Collier County

Development Services Advisory Committee Utility Subcommittee

1. Call to order - Chairman.
2. Approval of Agenda
3. New Business
 - a. Revision to the Utilities Standard Manual
4. Old Business
5. Public Speakers
6. Adjourn

Item	Sub-Section I Detail	Revision Summary	Fiscal Impact of change to Developer (Approx.)
Introduction			
1	Introduction	Modified third paragraph to 'introduction' explaining PE responsibilities. Web page reference change.	None
Section 1 – Design Criteria			
2	Cover Page	Web page reference change.	None
3	Table of Contents	Modified Table of Contents to reflect changes and correct scrivener's errors.	None
4	3.3 Wastewater pump stations	Revised section 3.3 Wastewater Pump Stations. Added section 3.3.1 Private Pump Stations.	None
Section 2 - Technical Specifications			
5	Cover Page	Web page reference change.	None
6	Table of Contents	Modified Table of Contents to reflect changes.	None
7	017839 Project Record Documents	Corrected scrivener's error on paragraph 1.3.C. Added notes m and n to part (3.2 B.6) identifying that m) meter boxes and n) Locations of direct bury, conduits, handholes, junction boxes and vaults for buried electric and communication c

PIPE RESTRAINT SCHEDULE

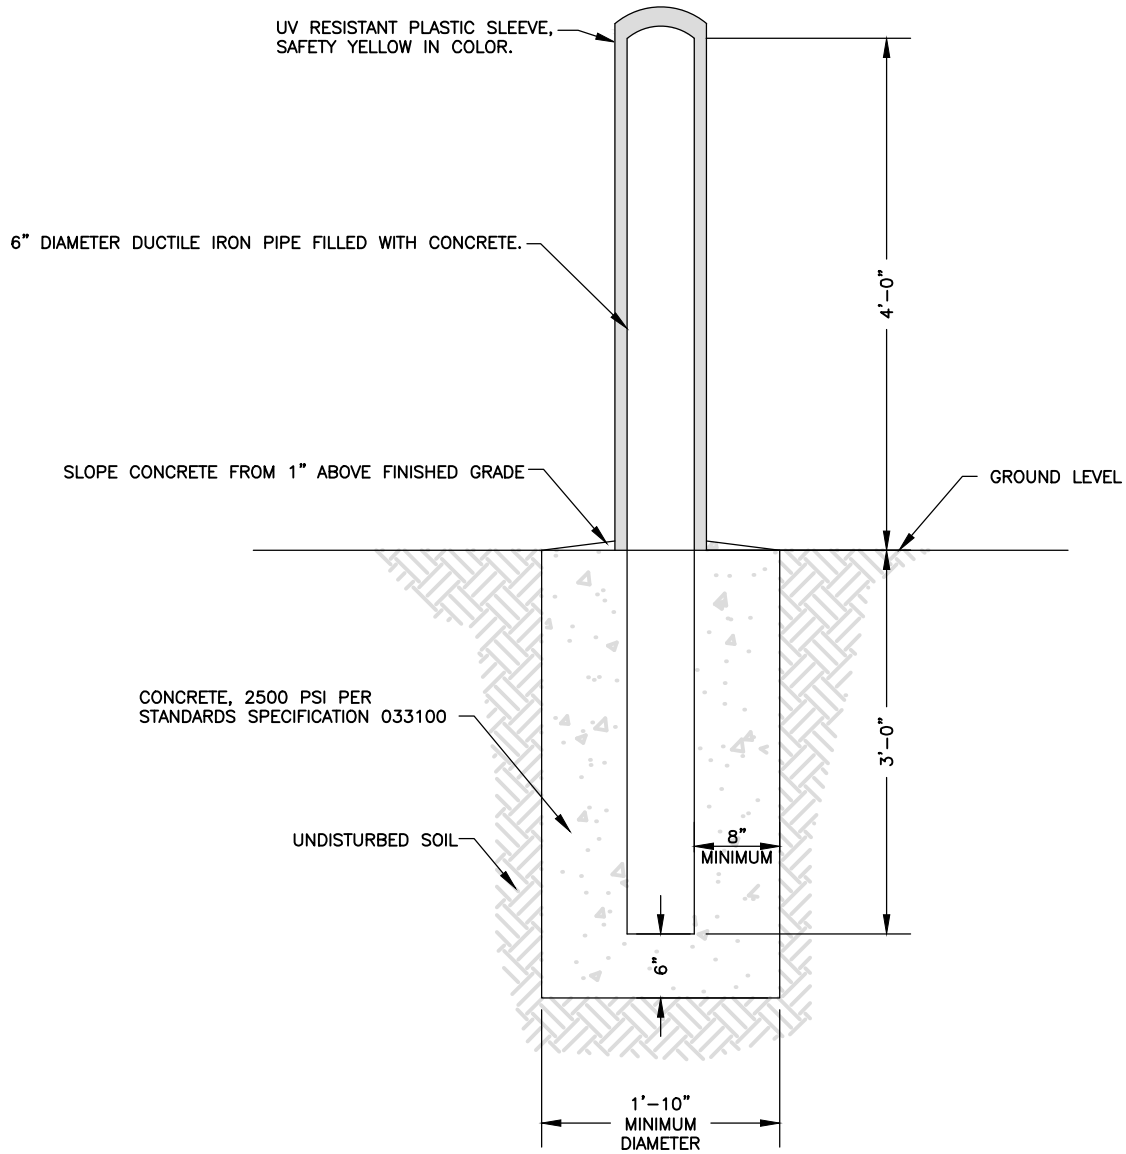
Item	Sub-Section Detail	Revision Summary	Fiscal Impact of change to Developer (Approx.)
27	G-10 Pipe Restraint Schedule	The detail was modified to include additional restrained pipe length tables for vertical bends.	None
28	G-12 IT Fiber-Optic Telecommunications	New Detail	\$15,000 approx. cost to install equipment for a fiber connected site. Additional cost will be required to install fiber to the pump station from the County's network.
29	W-1 Temporary Blowoff Assembly with Bacterial Sample Point Detail	Corrected PDF to reflect 2014 revision.	None
30	W-2 Automatic Water Main Flushing Device Detail	Corrected PDF to reflect 2014 revision.	None
31	W-3 Fire Hydrant Detail	Replaced FH connection point range (MIN 18", MAX 24") with note 'Height of the hydrant was set based upon manufacturers recommendation'.	None
32	W-3 Fire Hydrant Detail	Added distance from EOP/Curb to fire hydrant based on rural or urban area.	None

SHEET NO.
W-6

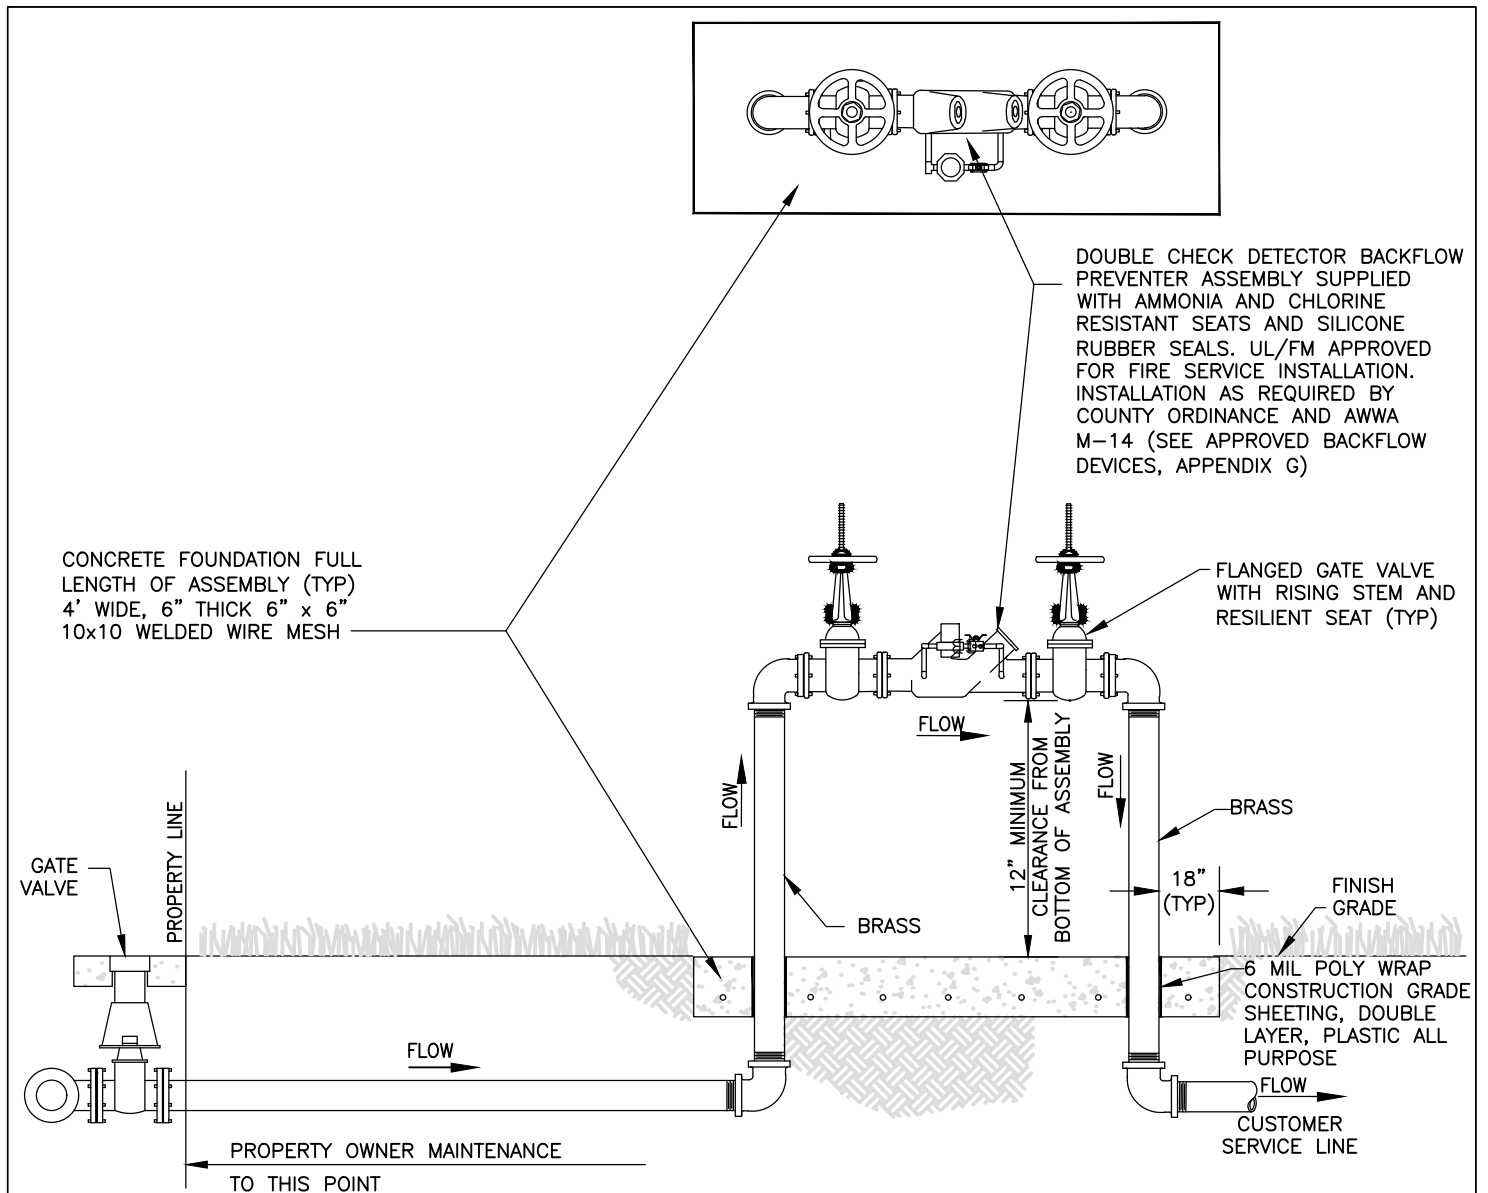
33	W-6 Permanent Bacterial Sample Point Detail	Brass models added to approved product list. Stainless steel models removed.	Potential cost savings
34	W-12 Typical short and long side water service meter setting detail for connection to water main	Temporary construction fence graphic added around the water meter boxes, with note referencing 'Note 8' on Detail W-12A. Revised meter callout to 'AMI/AMR meter'.	\$200/installation
35	W-12A Service connection sizing chart and notes	Added note # 8 to Equipment Specifications, calling out temporary construction fence installation.	\$200/installation
36	W-13 3" and over potable water meter assembly detail	Added note # 9 to Equipment Specifications including maintenance access in County CUE or R/W.	None

**PUMP STATION
DETAIL - PROFILE**

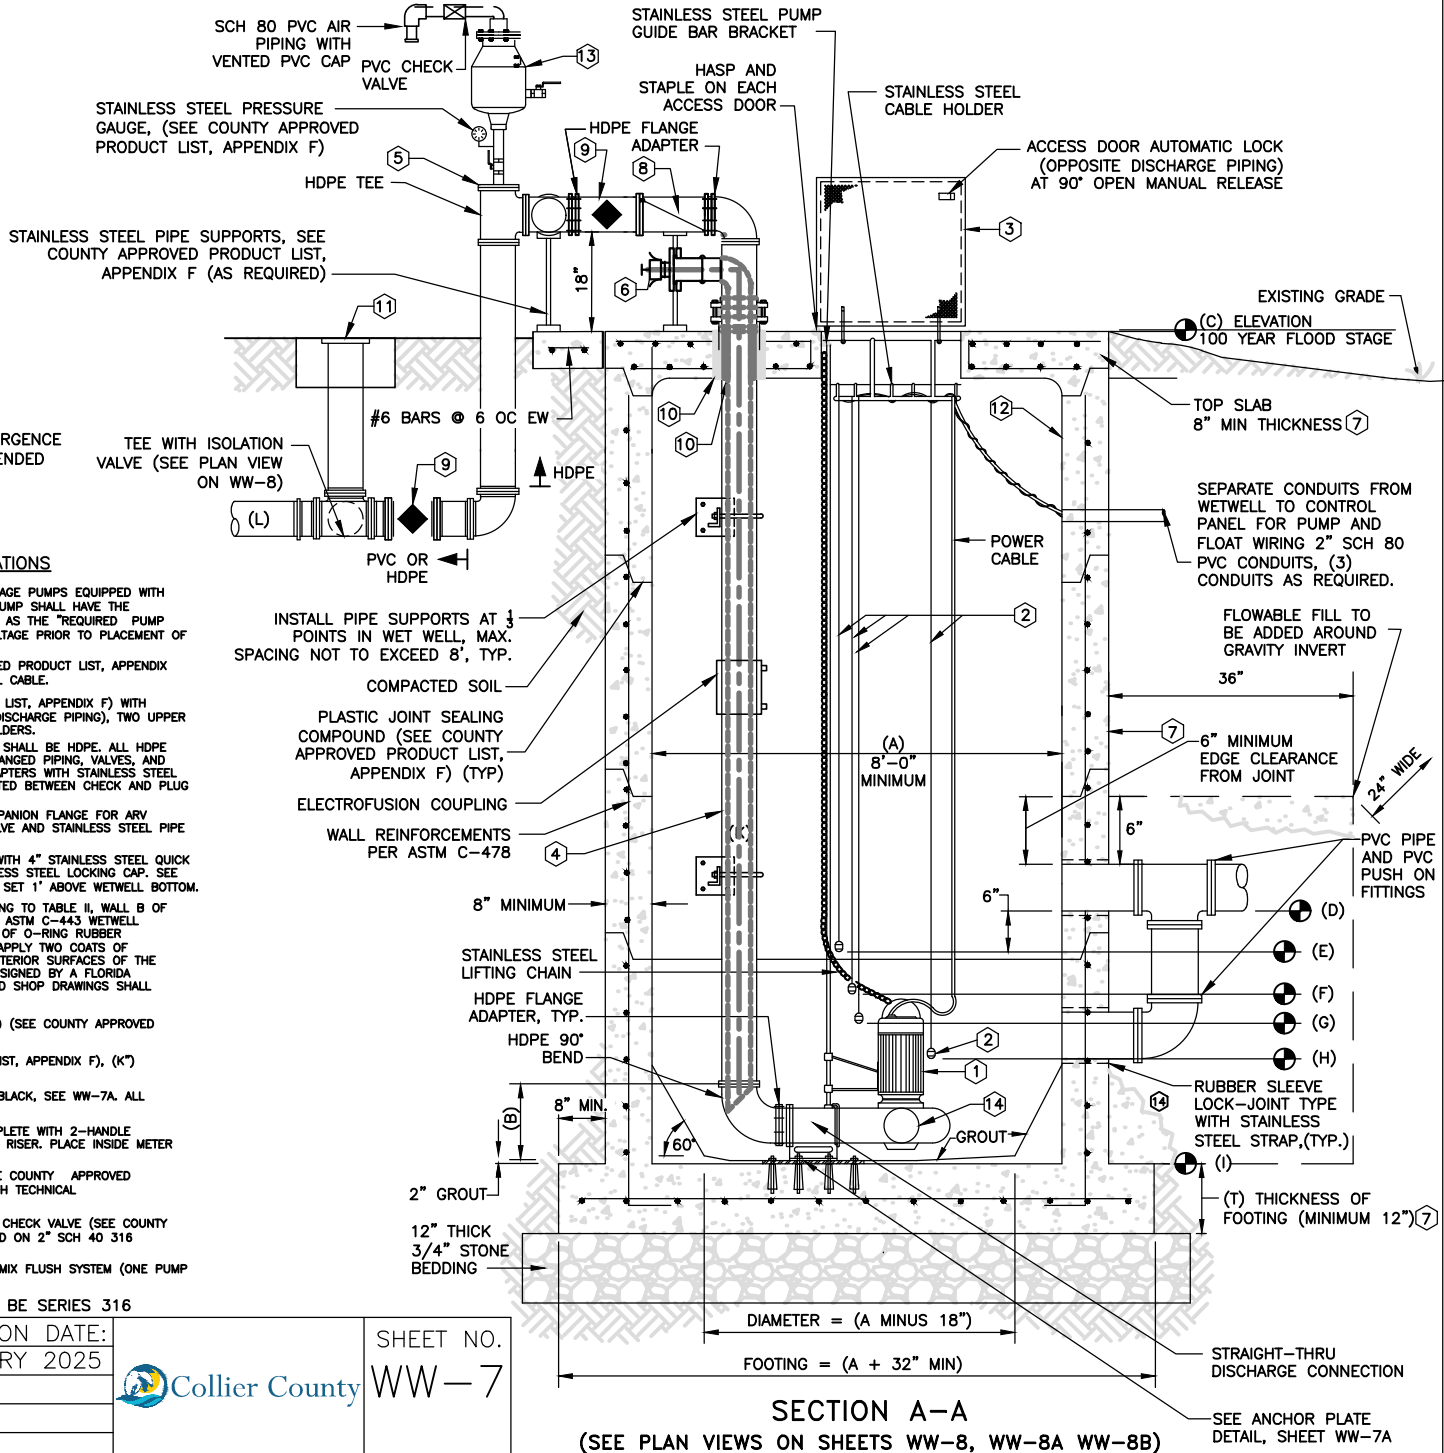
43	WW-6 Manhole ring and cover detail	Added note to call out for revised ring and cover models.	None
44	WW-7 Pump Station Detail - Profile	Mark # 3 for access door was modified by adding, '(Opposite discharge piping)'. Also added to detail callout.	None
45	WW-7 Pump Station Detail - Profile	Mark # 4 was modified by adding the sentence 'No spacers permitted between check and plug valves'.	None
46	WW-7 Pump Station Detail - Profile	Mark # 7 was modified by adding the sentence 'RAM-NEK may be used in lieu of o-ring rubber gaskets (see specification Section 034100)'.	None
47	WW-7 Pump Station Detail - Profile	Mark #7 was modified by adding the sentence, 'Pump Station wetwell shall be designed by a Florida Professional Engineer and signed and sealed shop drawings shall be submitted.'	None. Already a requirement

Item	Sub-Section I Detail	Revision Summary	Fiscal Impact of change to Developer (Approx.)
48	WW-7 Pump Station Detail - Profile	Mark # 8 was modified by adding the text 'with external weight/lever'.	None
49	WW-7 Pump Station Detail - Profile	Added reference to plan sheets under profile callout 'Section A-A'.	None
50	WW-7 Pump Station Detail - Profile	Removed rebar callouts for base slab and top slab. Added note, 'Wall reinforcing per ASTM C-478. Added note, 'Top slab, 8" min thickness'. Revised footer dimension to 'A+32" min'. Added mark references.	None
51	WW-7D Private Grinder Pump Station Detail	Detail added to County detail set.	None
52	WW-8 Pump Station Detail - Plan	Mark # 4 was modified by adding the sentence 'No spacers permitted between check and plug valves'.	None
53	WW-8 Pump Station Detail - Plan	Mark # 8 was modified by adding the text "with external weight/lever".	None
54	WW-8 Pump Station Detail - Plan	Mark # 14 was modified by adding the sentence "Single door panels to open away from wetwell".	None

COMMUNITY PUMP STATION WITH GENERATOR DETAIL - PLAN

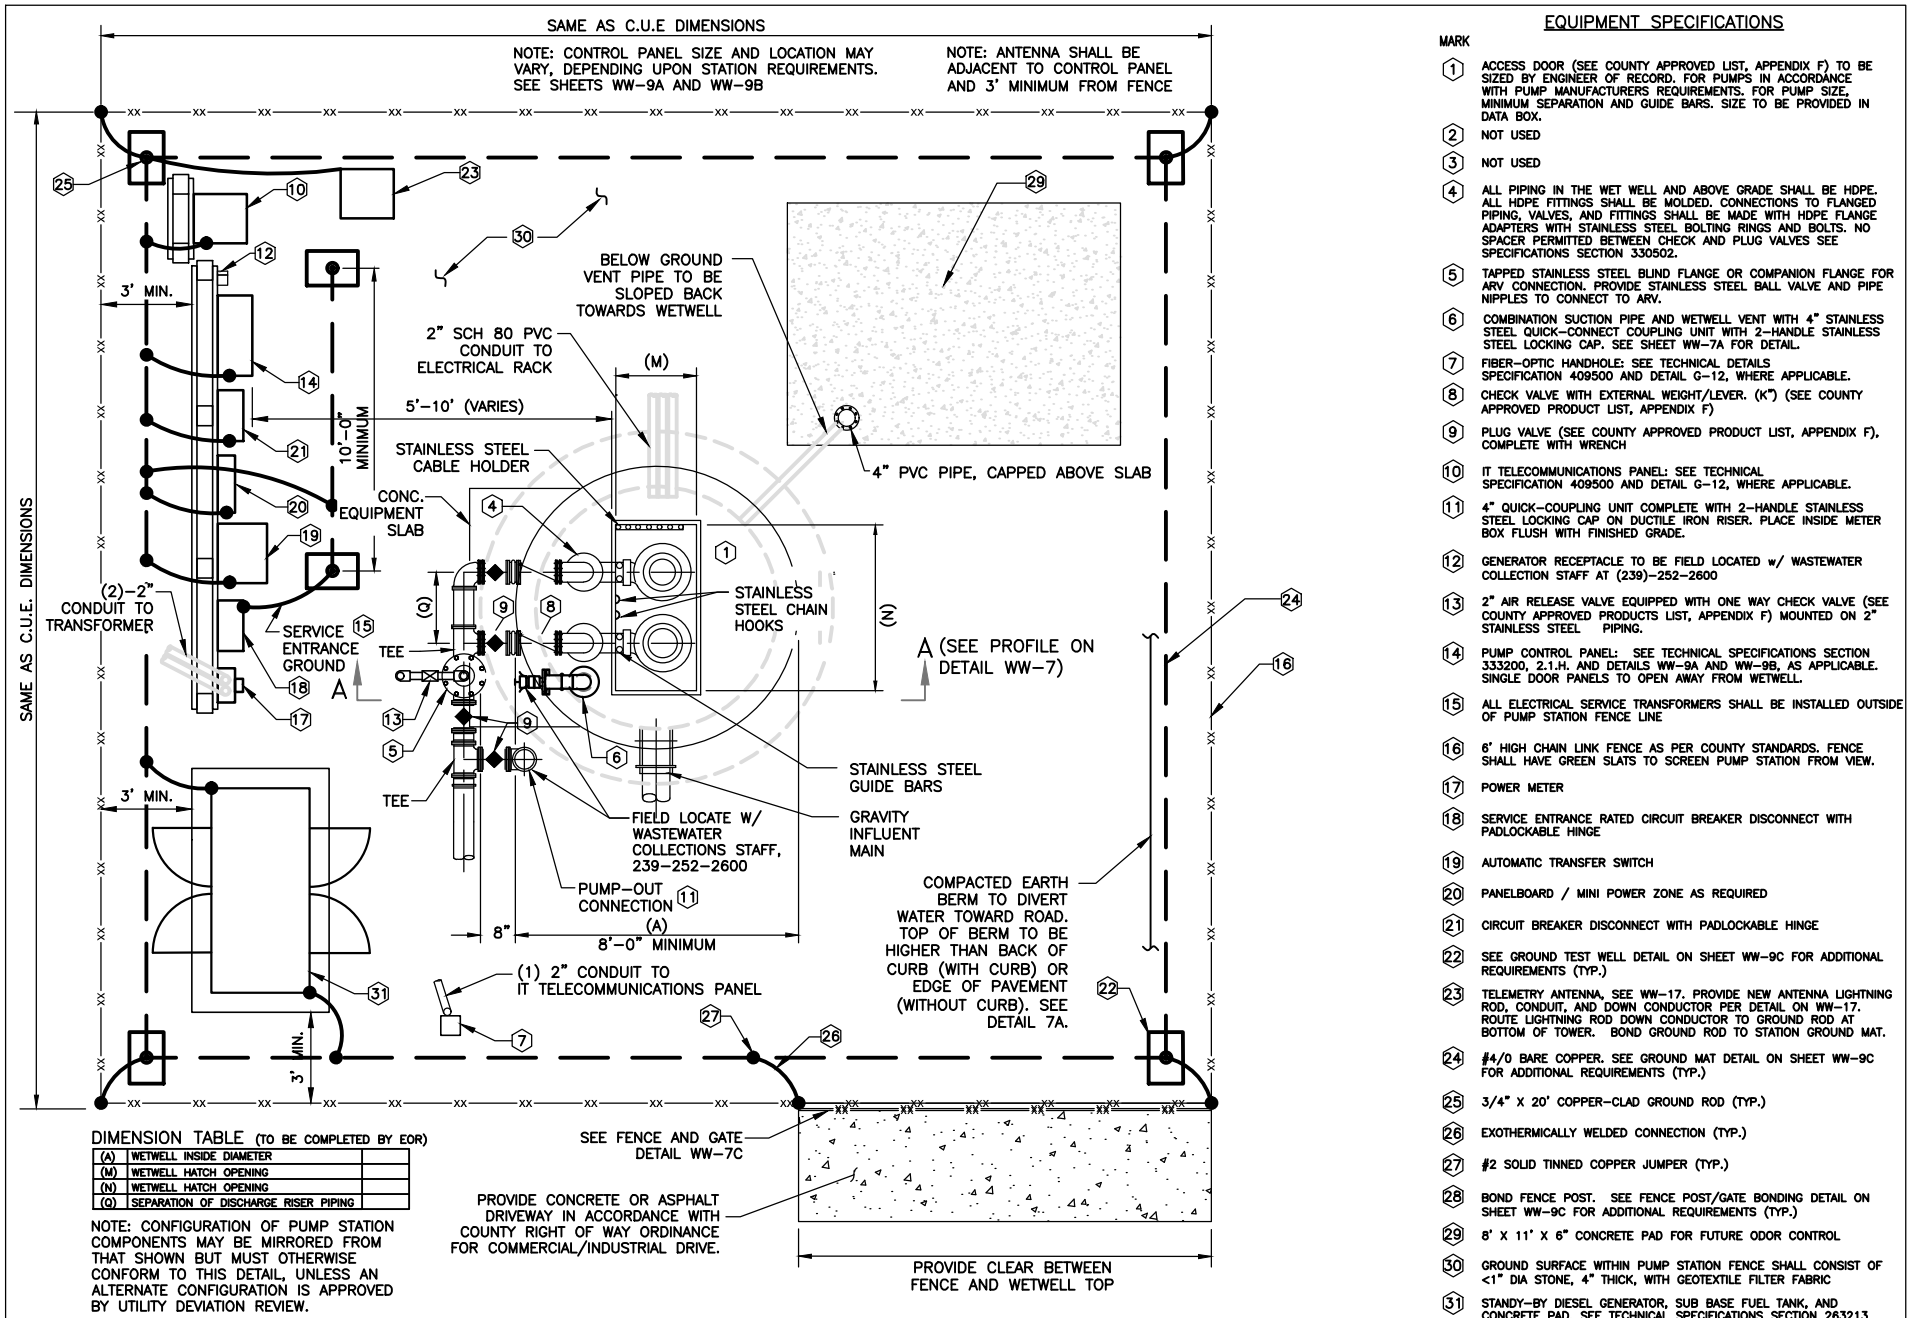
Item	Sub-Section I Detail	Revision Summary	Fiscal Impact of change to Developer (Approx.)
58	WW-8A Community Pump Station with Generator Detail - Plan	Mark # 4 was modified by adding the sentence 'No spacers permitted between check and plug valves'.	None
59	WW-8A Community Pump Station with Generator Detail - Plan	Mark # 7 was added: "Fiber-optic handhole: See technical details specification 409500 and detail G-12, where applicable". Conduit and handhole graphic added to the detail.	\$15,000 approx. cost to install equipment for a fiber connected site. Additional cost will be required to install fiber to the pump station from the County's network.
60	WW-8A Community Pump Station with Generator Detail - Plan	Mark # 8 was modified by adding the text "with external weight/lever".	None
61	WW-8A Community Pump Station with Generator Detail - Plan	Mark # 10 was added: "IT telecommunications panel: See technical specification 409500 and detail G-12, where applicable". IT telecommunications graphic added to the detail.	\$15,000 approx. cost to install equipment for a fiber connected site. Additional cost will be required to install fiber to the pump station from the County's network.

62	WW-8A Community Pump Station with Generator Detail - Plan	Mark # 14 was modified by adding the sentence "Single door panels to open away from wetwell".	None
63	WW-8A Community Pump Station with Generator Detail - Plan	Callout for access drive material was modified by deleting the option for grass covered porous pavement and leaving only the option for concrete or asphalt. Access drive dimension was set as the distance between the fence and the wetwell top.	Potential cost savings
64	WW-8A Community Pump Station with Generator Detail - Plan	Note added next to section A-A, referencing plan view on detail WW-7.	None

Item	Sub-Section I Detail	Revision Summary	Fiscal Impact of change to Developer (Approx.)
65	WW-8A Community Pump Station with Generator Detail - Plan	Note added next to Dimension Table, '(To be completed by EOR)'.	None
66	WW-8B Community Pump Station with Diesel Pump Detail - Plan	Mark # 2 was added: "Fiber-optic handhole: See technical details specification 409500 and detail G-12, where applicable". Conduit and handhole graphic added to the detail.	\$15,000 approx. cost to install equipment for a fiber connected site. Additional cost will be required to install fiber to the pump station from the County's network.
67	WW-8B Community Pump Station with Diesel Pump Detail - Plan	Mark # 4 was modified by adding the sentence "No spacers permitted between check and plug valves".	None
68	WW-8B Community Pump Station with Diesel Pump Detail - Plan	Mark # 7 was added: "Fiber-optic handhole: See technical details specification 409500 and detail G-12, where applicable". Conduit and handhole graphic added to the detail.	\$15,000 approx. cost to install equipment for a fiber connected site. Additional cost will be required to install fiber to the pump station from the County's network.
